# COVER SHEET

Mark-up Legend	
Building Review	
Engineering Review	
Fire Review	
Planning Review	
Public Works Review	
Traffic Review	
APPROVED	
BY	CITY OF PUYALLUP DEVELOPMENT ENGINEERING
DATE	
NOTE: THIS APPROVAL IS VOID AFTER 180 DAYS FROM APPROVAL DATE. THE CITY WILL NOT BE RESPONSIBLE FOR ERRORS AND/OR OMISSIONS ON THESE PLANS. FIELD CONDITIONS MAY DICTATE CHANGES TO THESE PLANS AS DETERMINED BY THE DEVELOPMENT ENGINEERING MANAGER.

FOR  
**ARCO ampm PUYALLUP**  
SEC. 33, TWN. 20 N, RGE. 4 E, W.M.  
CITY OF PUYALLUP, PIERCE COUNTY

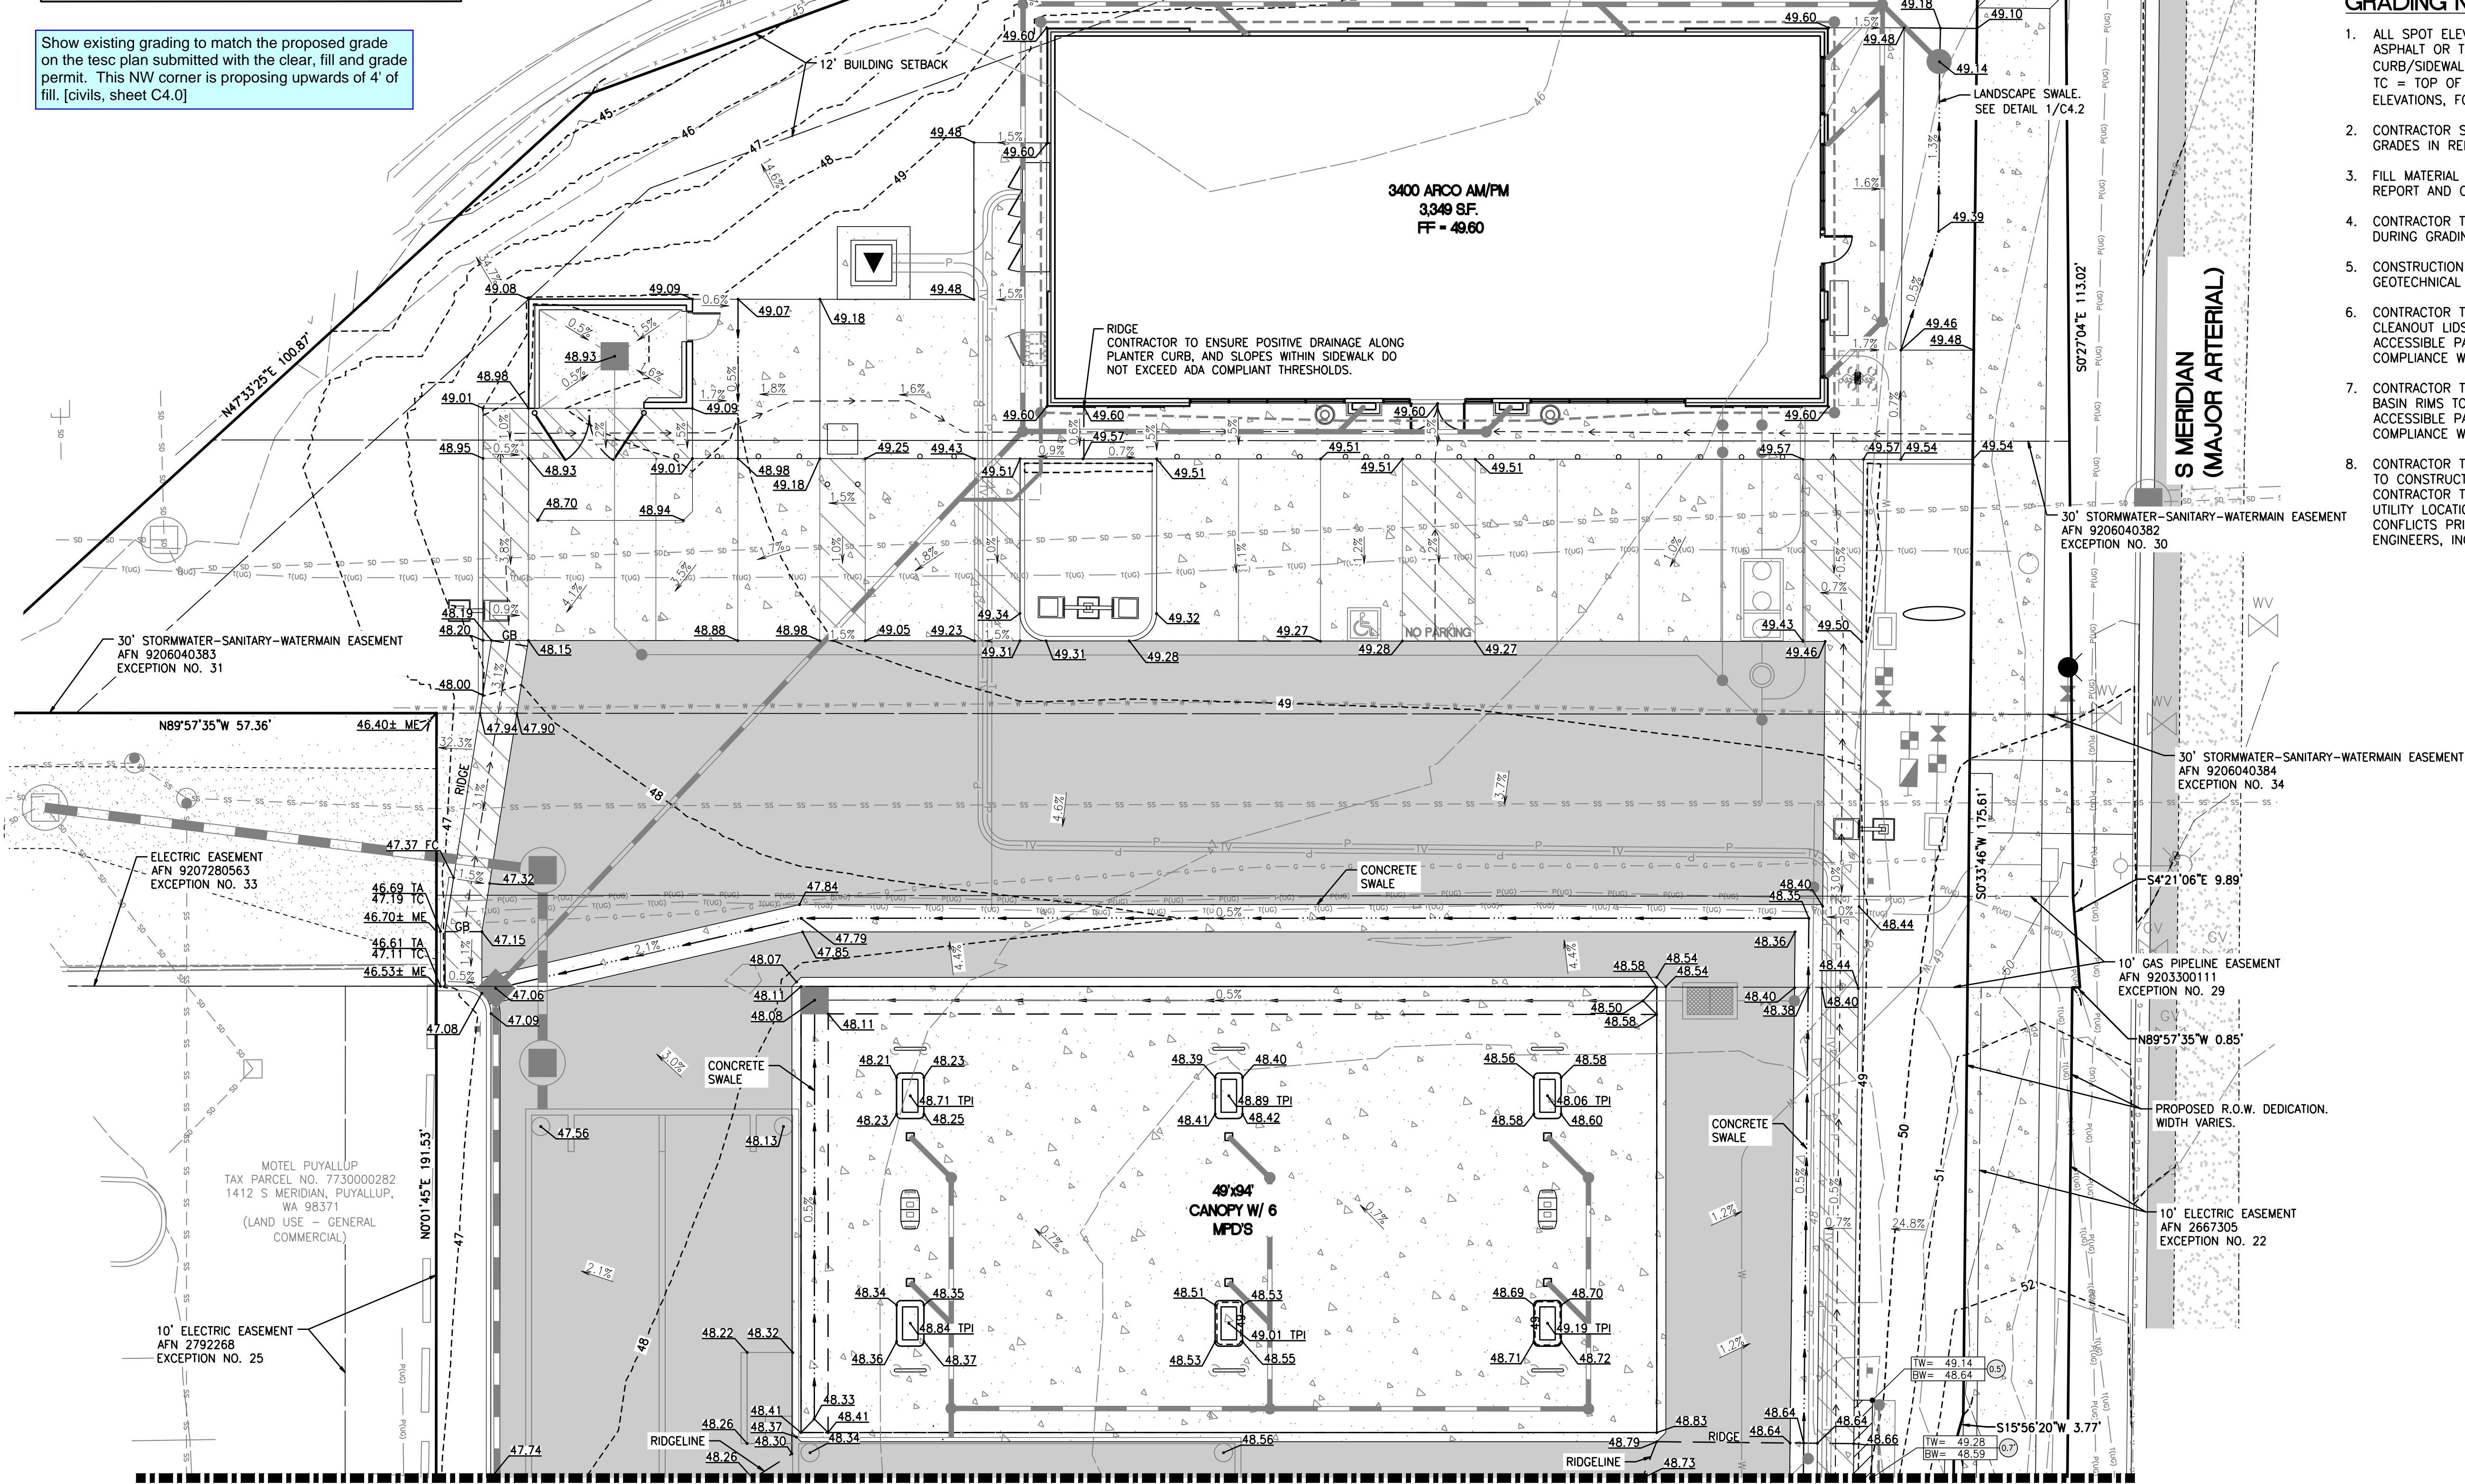
Show existing grading to match the proposed grade on the tesc plan submitted with the clear, fill and grade permit. This NW corner is proposing upwards of 4' of fill. [civils, sheet C4.0]

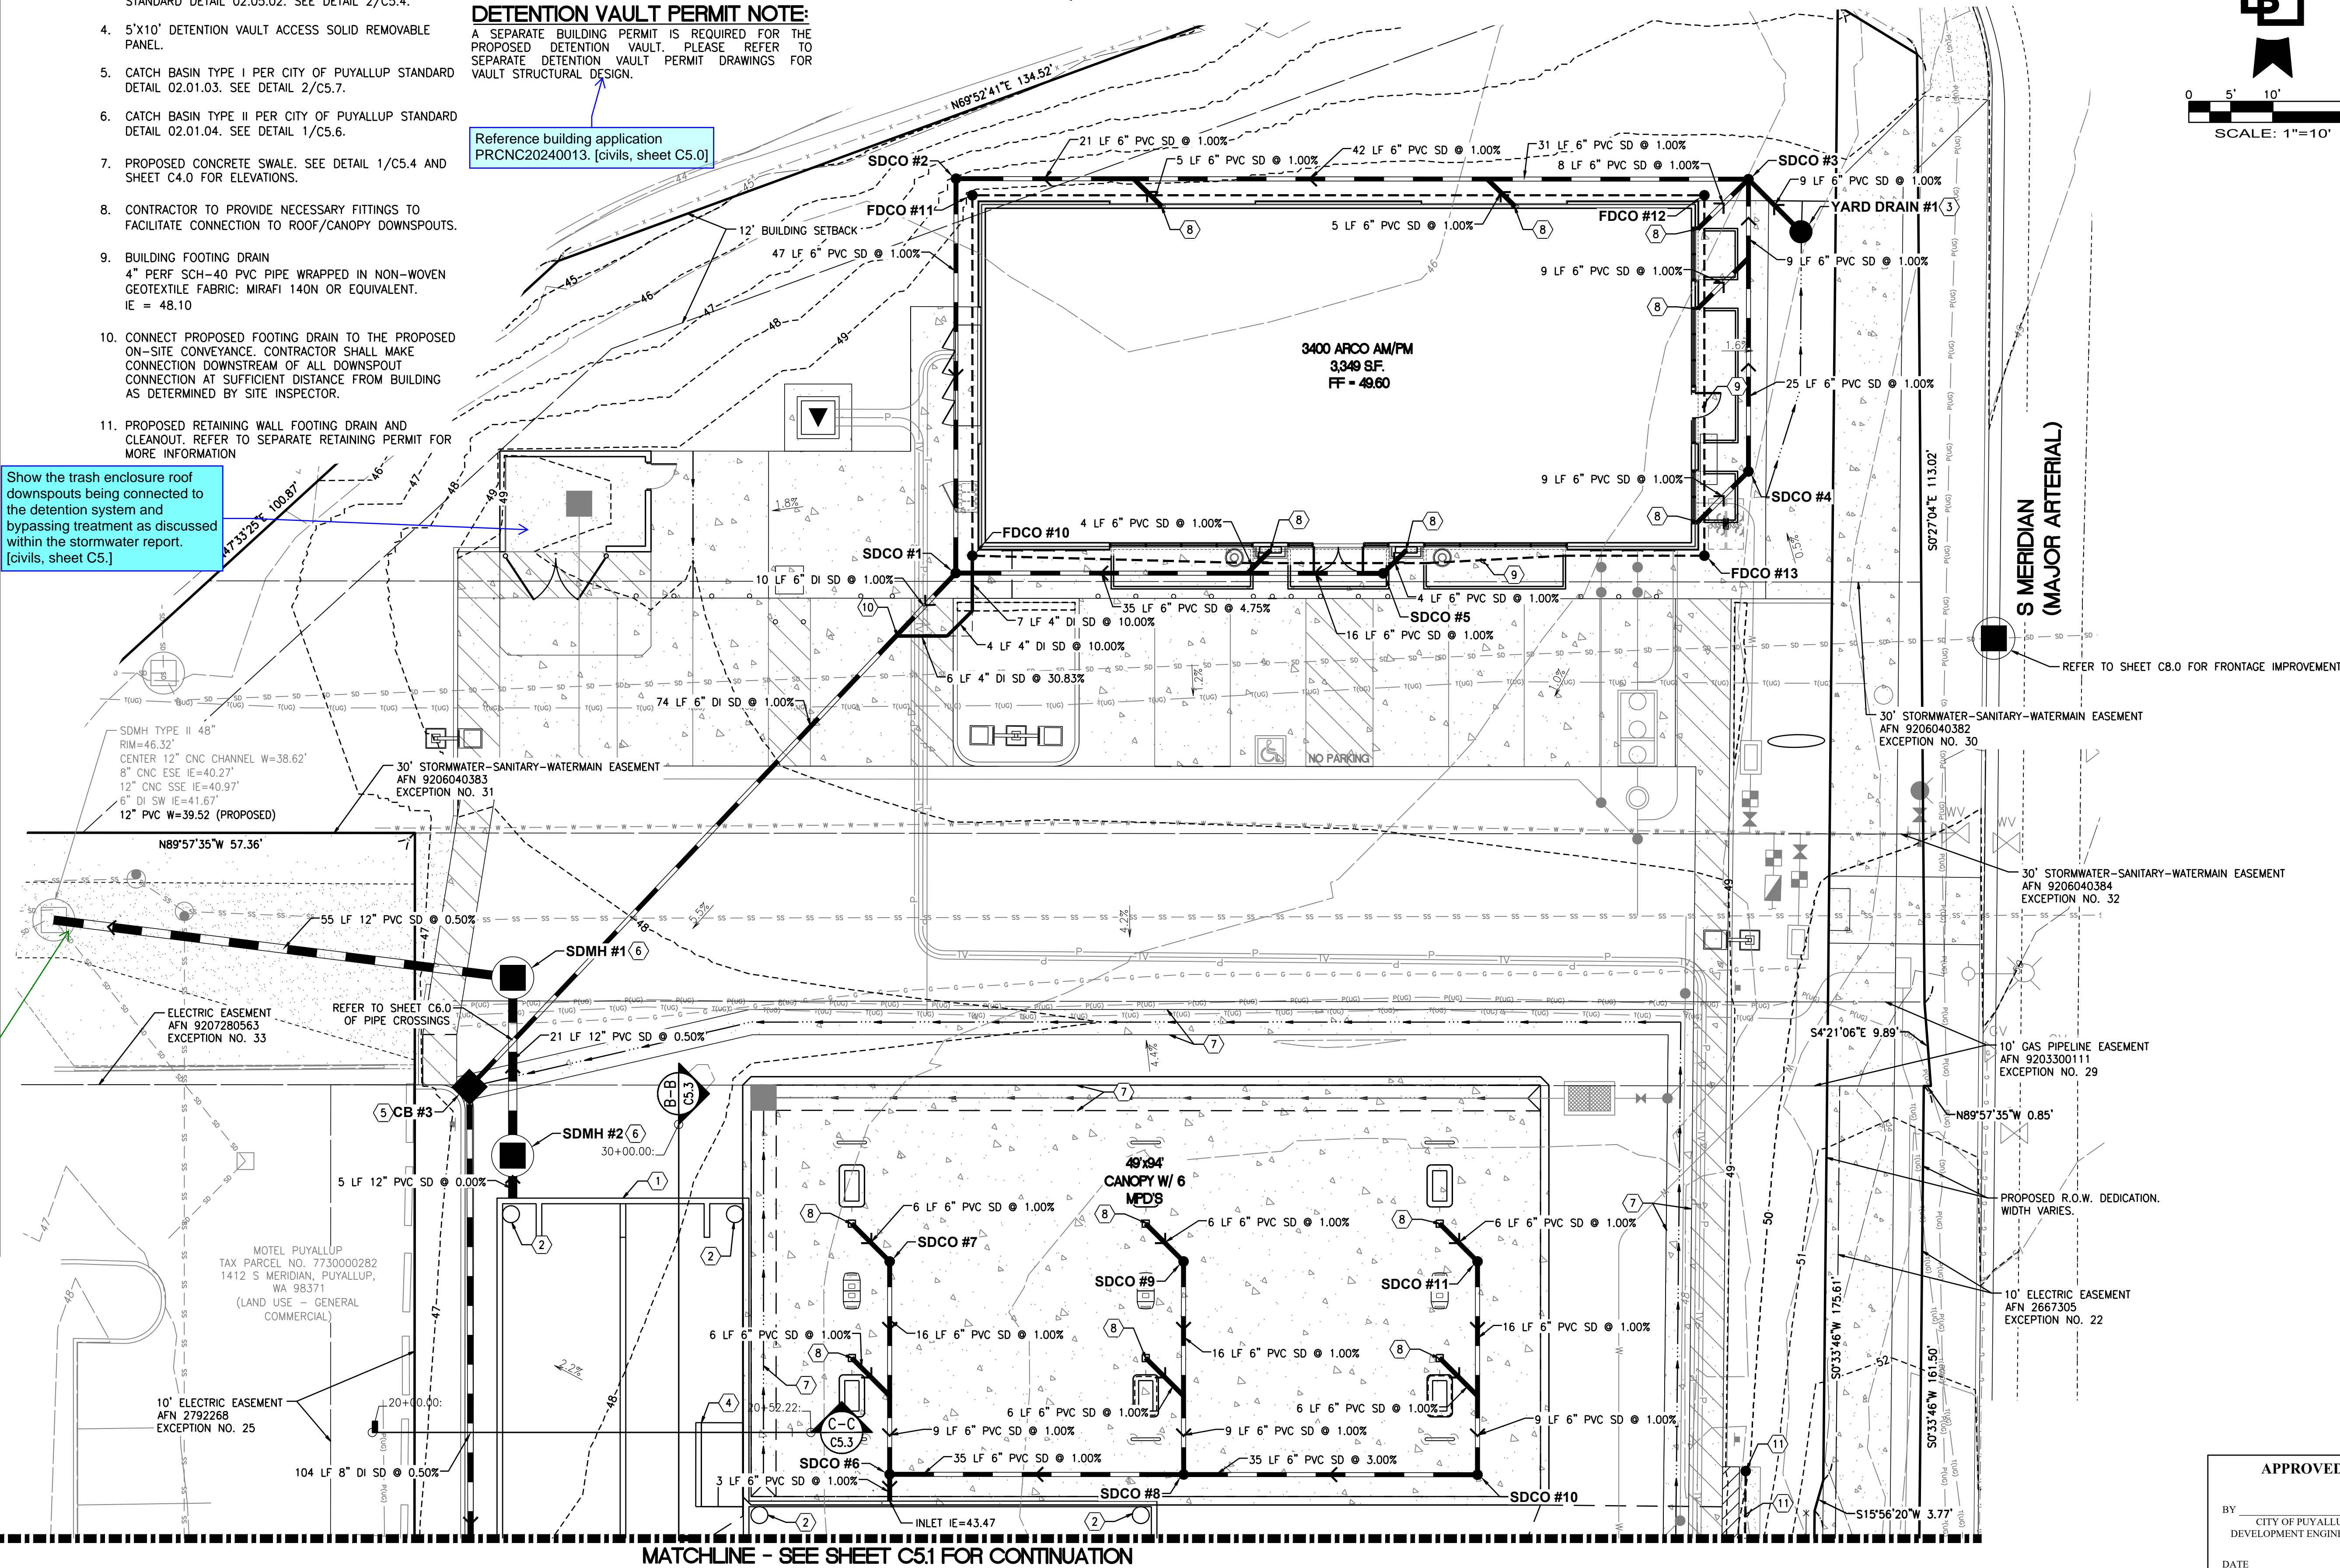
Reference building application PRCNC20240013. [civils, sheet C5.0]

The collections division prefers that the stormwater from this proposed system discharges to the existing 30 inch storm pipe and not this manhole. This is the older of the two systems and it is unknown as to the full condition downstream. [civil resub, sheet 5.0]

Revise storm pipe discharger per collection's department comment. [civils, sheet C5.0]

DRAINAGE PLAN - SOUTH

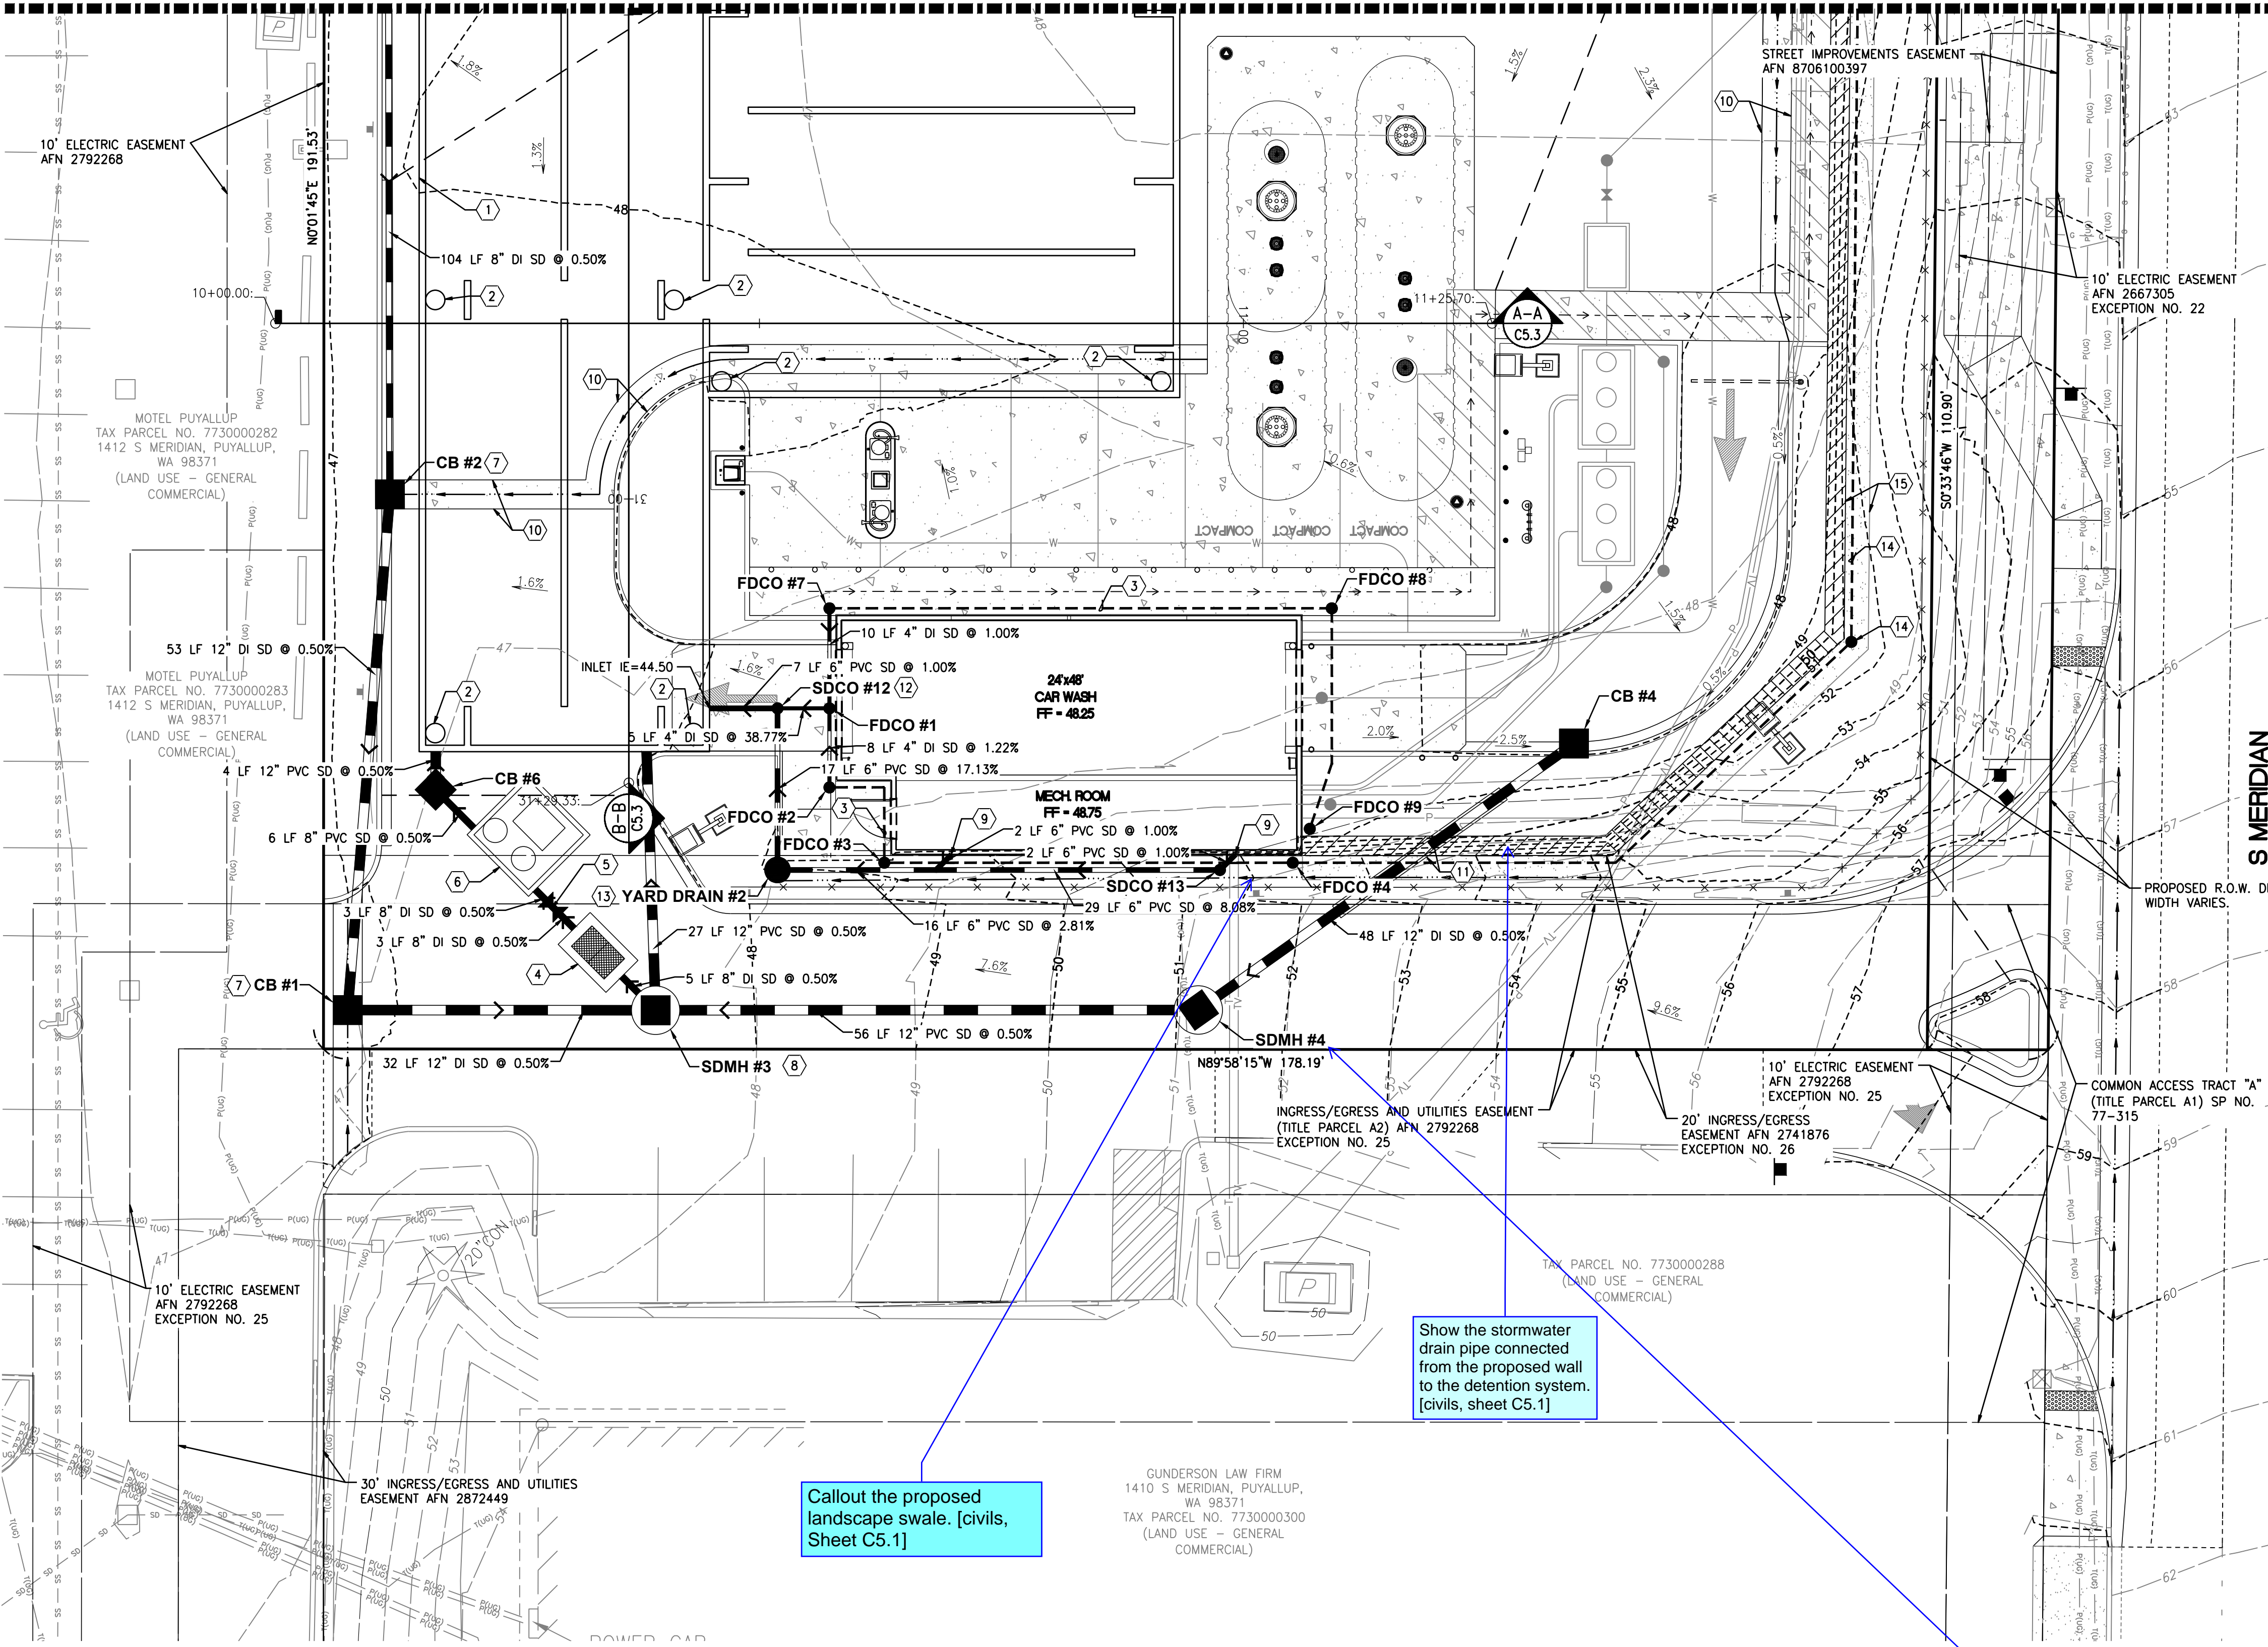
Show the stormwater drain pipe connected from the proposed wall to the detention system. [civils, sheet C5.1]

Callout the proposed landscape swale. [civils, Sheet C5.1]

SDMH #3 and #4 plans and stormwater structural table do not match the callouts. SDMH #3 is proposing the flow splitter. [civils, sheet C5.1]
